00 91 01 ADDENDUM NUMBER 01

Owner: City of Arlington, Texas
 John F. Kubala WTP West High Service Pump Station Pump 4 & 5
Project: Addition
Project No.: WUTR19020
Addendum No. 01
Addendum Date: December 1, 2021

PROPOSED SITE PLAN

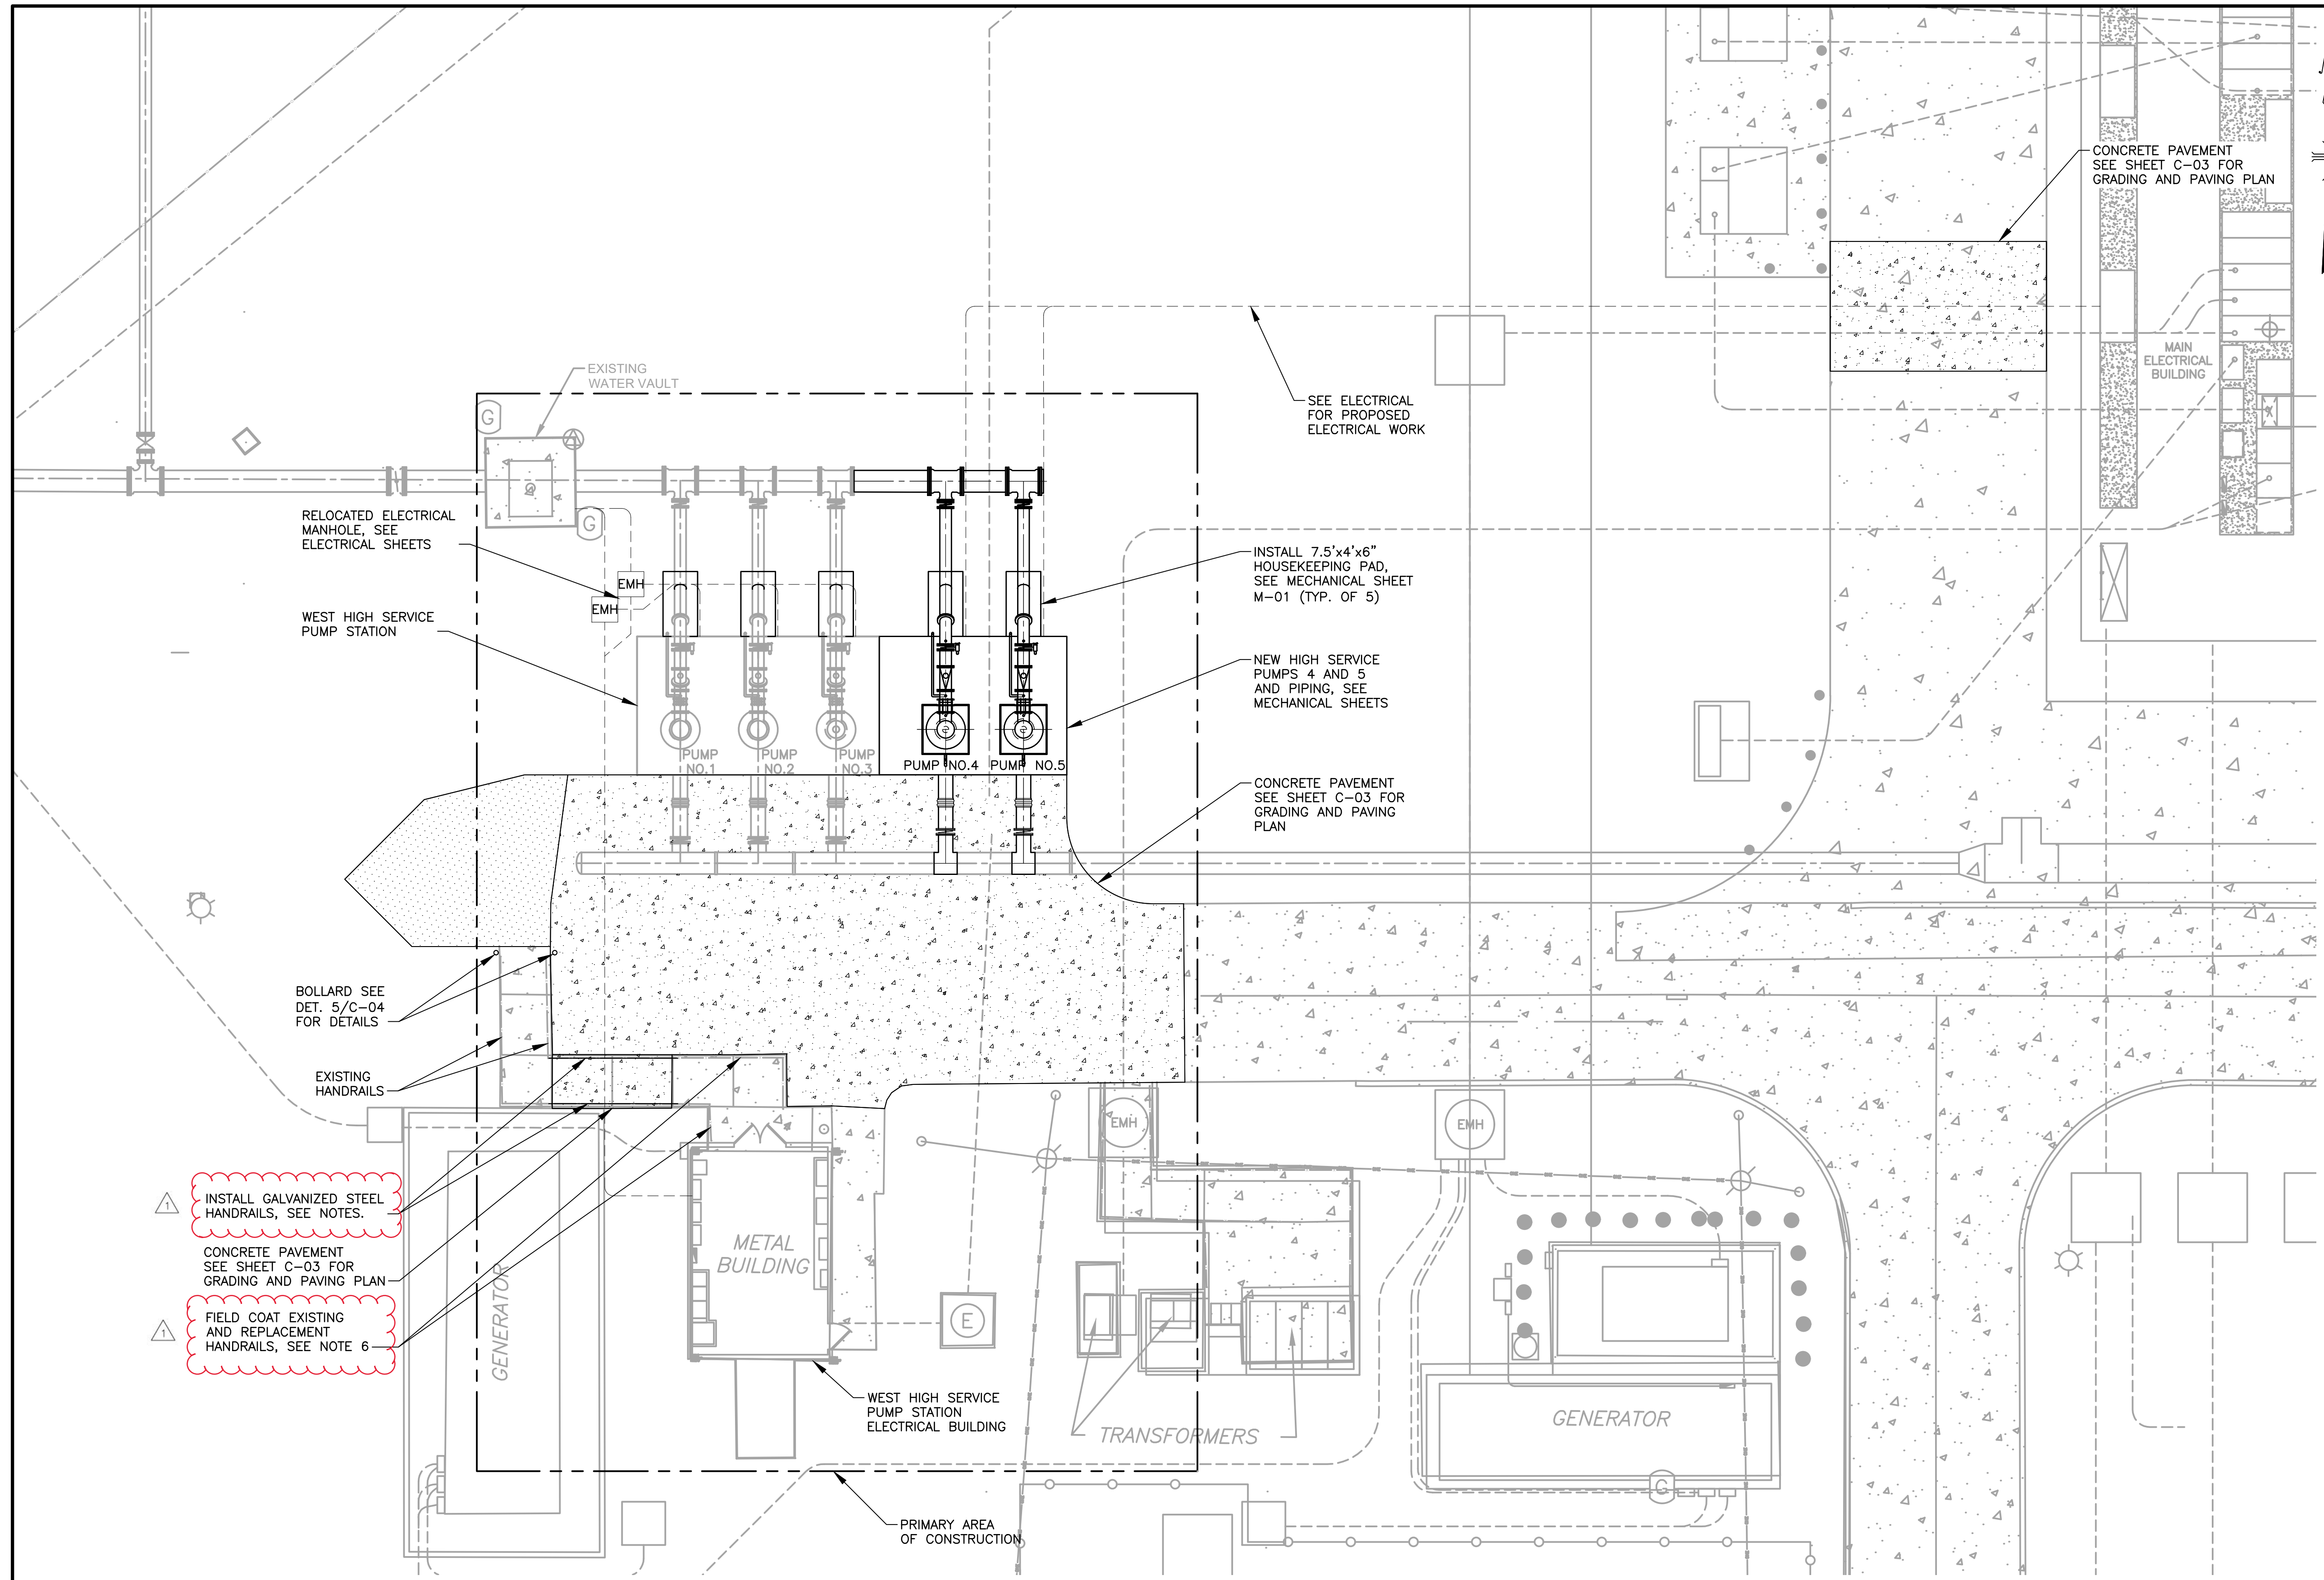
- 3.01 Sheet **C-02 – PROPOSED SITE PLAN**
 - A. Add General Note 1 as follows:

“1. PROVIDE REPLACEMENT SECTIONS NECESSARY TO FACILITATE REMOVAL AND REPLACEMENT OF THE EXISTING HANDRAILS INDICATED ON THE DRAWINGS. IT IS ACCEPTABLE TO REUSE SEGMENTS OF EXISTING HANDRAIL SYSTEM WITH THE APPROVAL OF THE ENGINEER.”
 - B. Add General Note 2 as follows:

“2. THE CONTRACTOR SHALL FIELD CUT, STORE AND PROTECT EXISTING HANDRAIL SECTIONS.”
 - C. Add General Note 3 as follows:

“3. THE CONTRACTOR SHALL PROVIDE REPLACEMENT SECTIONS FOR ANY DAMAGED PORTIONS OF RAILING OR POSTS. REPLACEMENT SECTIONS SHALL BE SHOP GALVANIZED.”
 - D. Add General Note 4 as follows:

“4. FIELD WELDING PROCEDURES SHALL COMPLY WITH AWS D19.0 REMOVE ZINC COATING ON EXISTING AND REPLACEMENT COMPONENTS ONE TO FOUR INCHES FROM EACH SIDE OF ALL REQUIRED FIELD WELDS. FOLLOWING COMPLETION OF WELDING GRIND AREA SMOOTH AND REPAIR FINISH IN ACCORDANCE WITH ASTM A 780.”
 - E. Add General Note 5 as follows:

“5. COAT FIELD WELDS AND ADJACENT BARE STEEL AREAS IN ACCORDANCE WITH THE SPECIFICATIONS. COATING THICKNESS SHALL BE 50 PERCENT MORE THAN SURROUNDING SHOP GALVANIZED THICKNESS OR 4.0 MILS WHICHEVER IS LESS. THICKNESS MEASUREMENT SHALL BE TAKEN WITH EITHER MAGNETIC, ELECTROMAGNETIC OR EDDY CURRENT GAUGE.”

F. Add General Note 6 as follows:

“6. THE CONTRACTOR SHALL FIELD (COLOR) COAT BOTH THE REPLACEMENT AND EXISTING (LEFT IN PLACE) GALVANIZED STEEL HANDRAIL IN ACCORDANCE WITH THE SPECIFICATIONS. BASE BIDS ON FIELD COATING OF 100 LF OF HANDRAIL SYSTEM COMPRISED OF UPPER RAILS, MIDDLE RAILS AND UPRIGHTS (POSTS). IF DIRECTED BY THE OWNER TO LEAVE HANDRAILING WITH THE SHOP APPLIED GALVANIZED FINISH, THE CONTRACTOR SHALL CREDIT THE OWNER WITH THE COST OF MATERIALS AND LABOR REQUIRED TO FIELD COAT THE RAILINGS.”

G. Add new callout to the handrails:

“FIELD COAT EXISTING AND REPLACEMENT HANDRAILS, SEE NOTE 6”
